DOCUMENTATION TRANSMITTAL

NONCONFORMANCE REPORT

C-00804

SAFETY CONCERN AND REPORTABILITY EVALUATION

ULTRASONIC THICKNESS MEASUREMENT
TEST REPORT - 010101

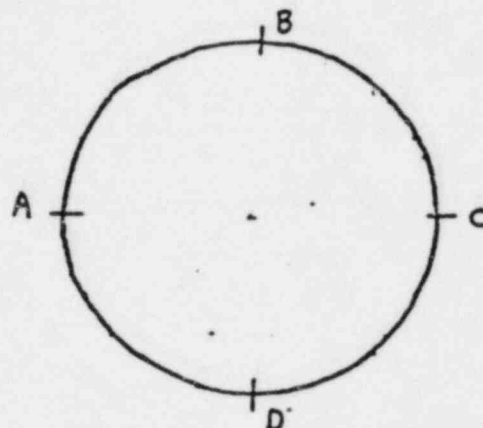
26" PIPE SPOOL S 632-1-9 PART OF LINE
2ELB AT VENDOR WELD C HAS A WALL THICKNESS
OF .863 AND .890. AREA OF VIOLATION IS ON THE
SOUTH SIDE OF PIPE LOCATED
DIRECTLY IN THE CENTER
OF THE WELD CAP AND 1/2 INCH
ADJACENT TO THE CENTER
TOWARDS THE 45° FITTING.

* THIS UT REPORT 33257 STATES
WELD NUMBER AS FW N. THIS
N DESIGNATION WAS USED FOR
FIELD ENGINEERING USE ONLY.
THE WELD IN QUESTION IS VENDOR
WELD C ON ITT GRINNELL 2ELB-9
GEO CONSTRUCT

THE AREAS OF SHOPWELD ON SPOOL 2ELB-9-S-632-1-9 IDENTIFIED AS
VIOLATING THE 0.896 MINIMUM WALL THICKNESS SHALL BE BUILT UP BY WELDING
TO THE REQUIRED THICKNESS. WELD BUILDUP SHALL BE TREATED AS A REPAIR
OF THE WELD. WELD PROCEDURE SHALL BE P1-AT-L6 (CVN). NO
POST WELD HEAT TREATMENT IS REQUIRED. THE REPAIRED AREA SHALL
BE RADIOGRAPHED IN ACCORDANCE WITH RT-ASME AFTER WELDING

P&ID M-632, Sheet 1 (2ELB-9 and 10)

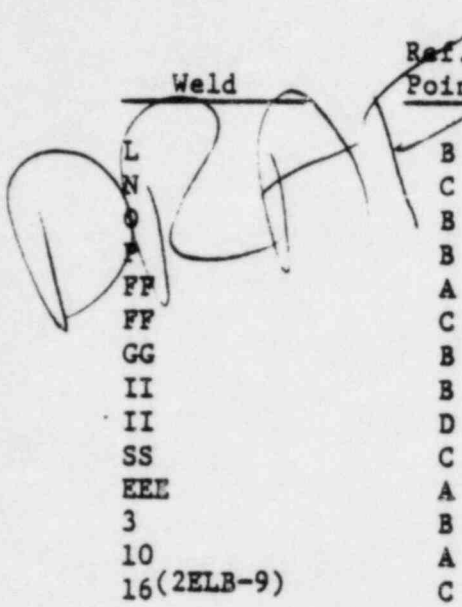
Eighty-six welds out of approximately 160 have been measured. Measurements taken to date (References B and C) indicate adequate wall thickness except for the following welds, where the thickness at a point in the circumference is below the minimum:

Weld	Ref. Point	Maximum Negative Variance	Average Variance (Along Length)
L	B	-.005"	+.061"
N	C	-.096"	+.003"
O	B	-.023"	+.133"
P	B	-.010"	+.088"
FF	A	-.025"	+.030"
FF	C	-.037"	+.039"
GG	B	-.005"	+.047"
II	B	-.033"	+.038"
II	D	-.026"	+.034"
SS	C	-.043"	+.097"
EEE	A	-.023"	+.091"
3	B	-.004"	+.056"
10	A	-.002"	+.046"
16(2ELB-9)	C	-.010"	+.063"

The program of measurement will be continued to assure that adequate wall thickness exists throughout the main steam piping inside containment. All areas which do not have adequate wall thickness will be buildup as required to meet the appropriate thickness.
